FLOOD STUDY
WYLDEWOOD CREEK
TOWN OF COLLINGWOOD

PREPARED FOR:
BRANDY LANE CORPORATION /
GEORGIAN BAY HOTEL

SEPTEMBER 2020

NVCA Email dated April 28, 2020
Comment Response Matrix

CONSTRAINTS PLAN

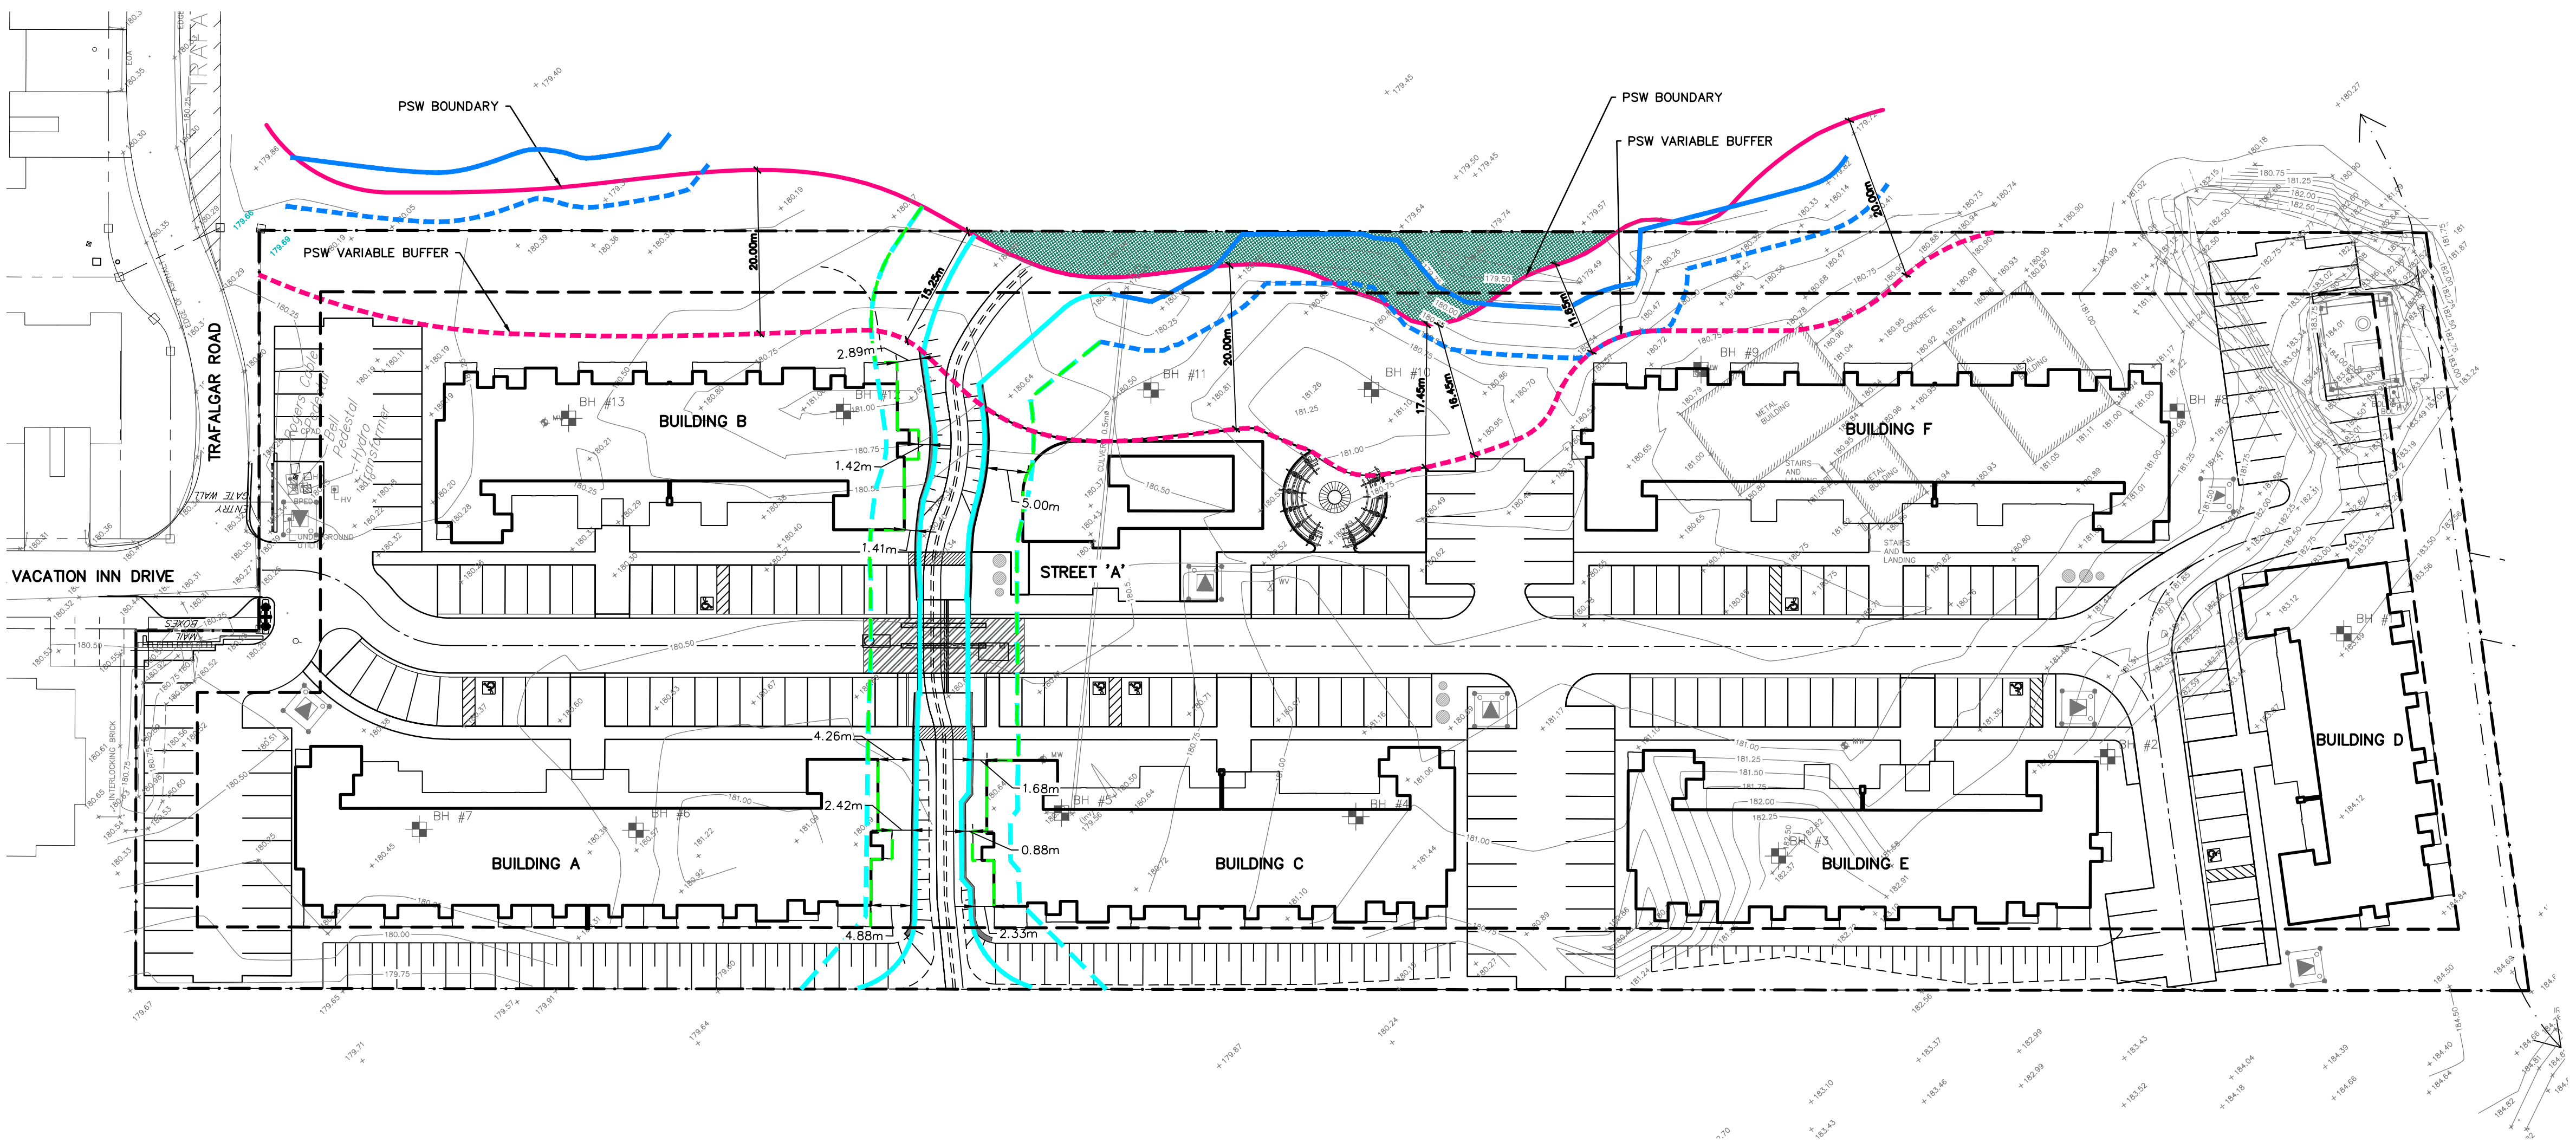
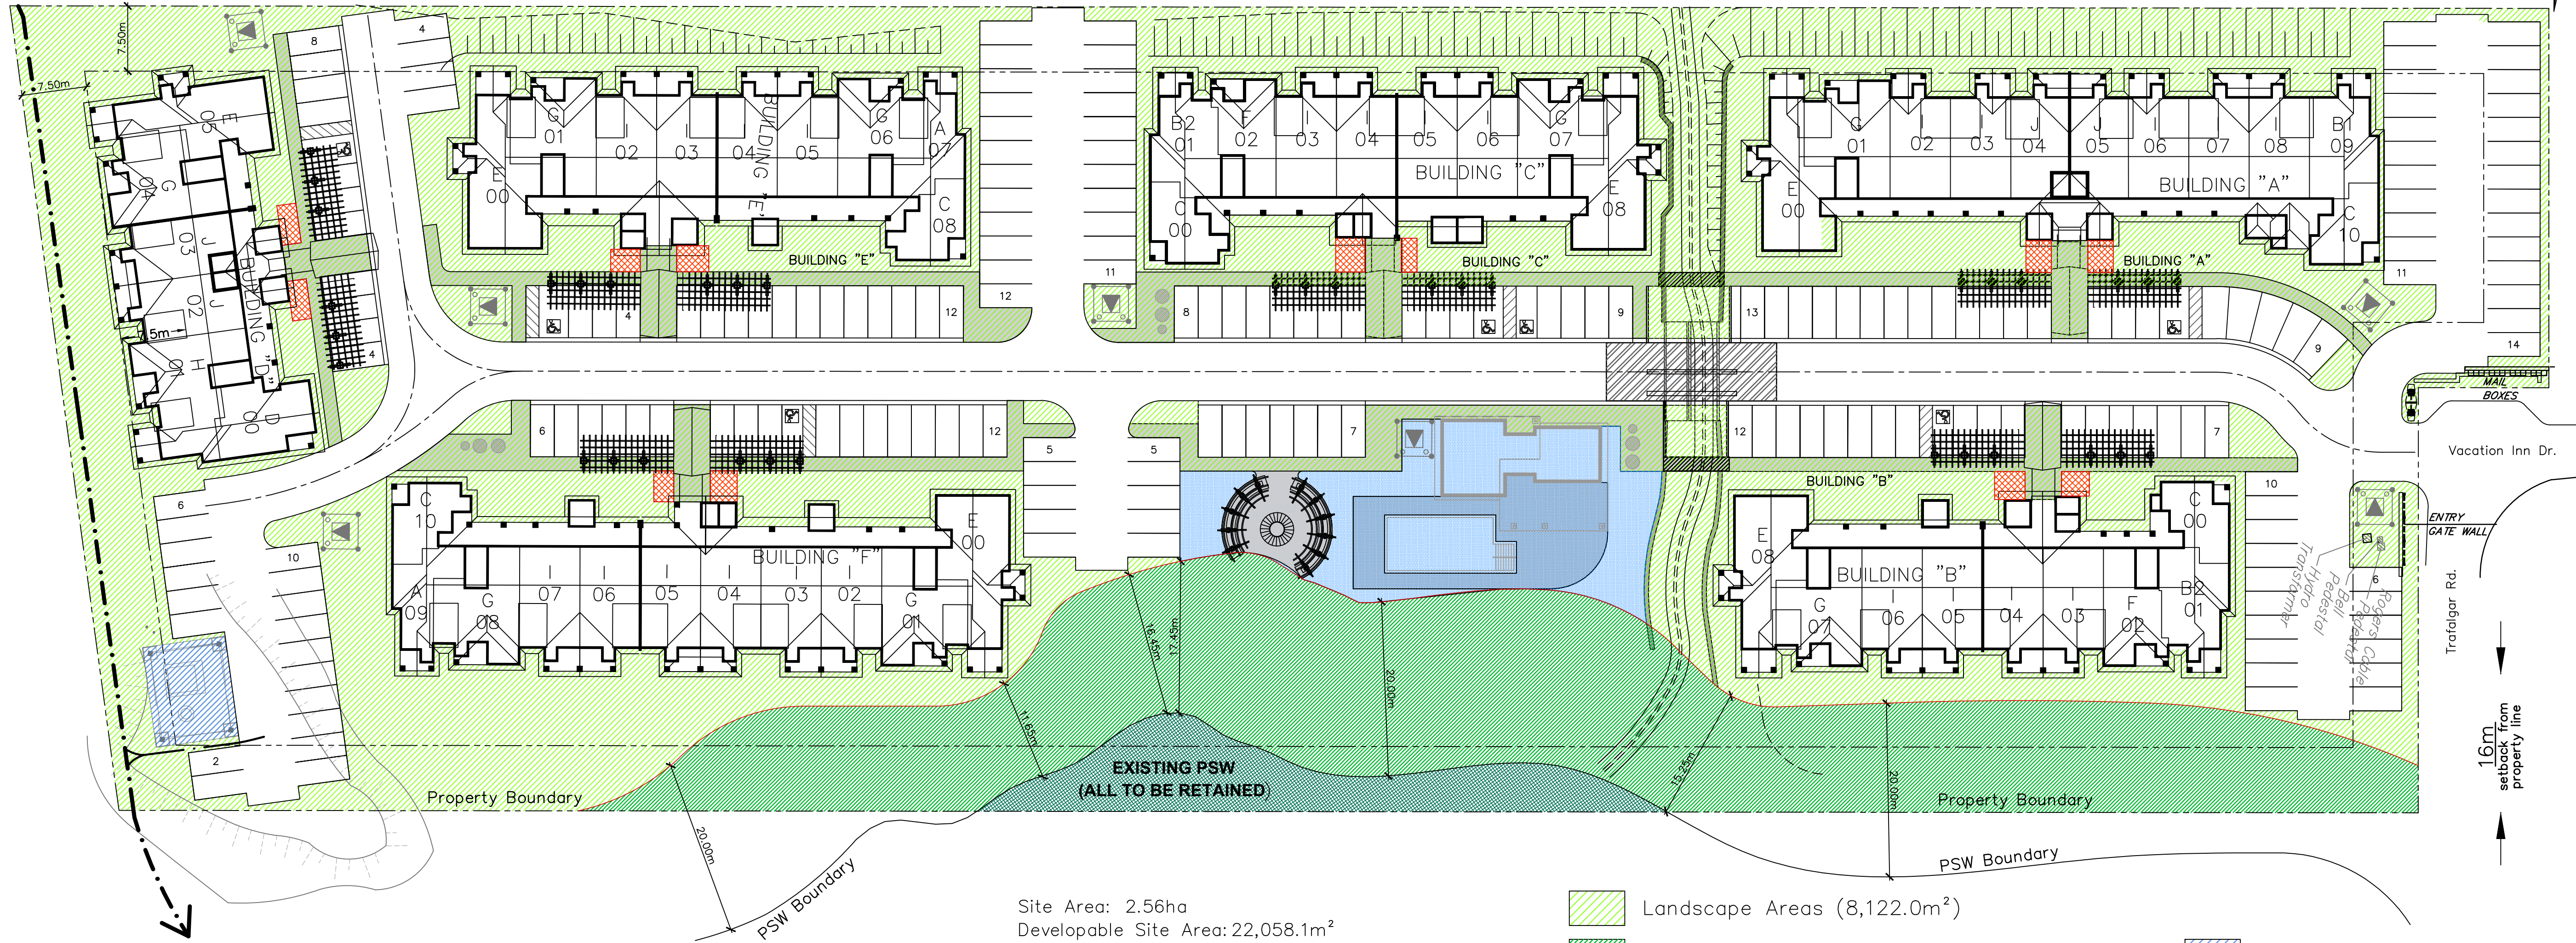
In order to accurately determine the appropriate limits to development, NVCA request that a scaleable drawing be provided (using surveyed data points) which illustrates the following items:

- The Cranberry Marsh high-water elevation of 179.80m + 6m buffer
- The Regional storm elevation associated with the engineered channel + 6m buffer (i.e. flood hazard access allowance)
- The delineated boundary of the PSW, plus variable buffer (averaged 30m) per latest concept plan.

At this time, a Preliminary Constraints Plan has been prepared and is enclosed within this letter. The Constraints Plan will be subject to refinement through additional design and analysis, as well as the outcome of the discussion regarding the 6m buffer from the engineered channel.

The Cranberry Marsh has a Regulated High Water Elevation of 179.80 masl, associated with the Regional Storm Event. The limits of the Regional Flood Event for the Cranberry Marsh have been delineated on the site based on the topographic survey completed by KRCMAR. Refer to the enclosed Constraints Plan.
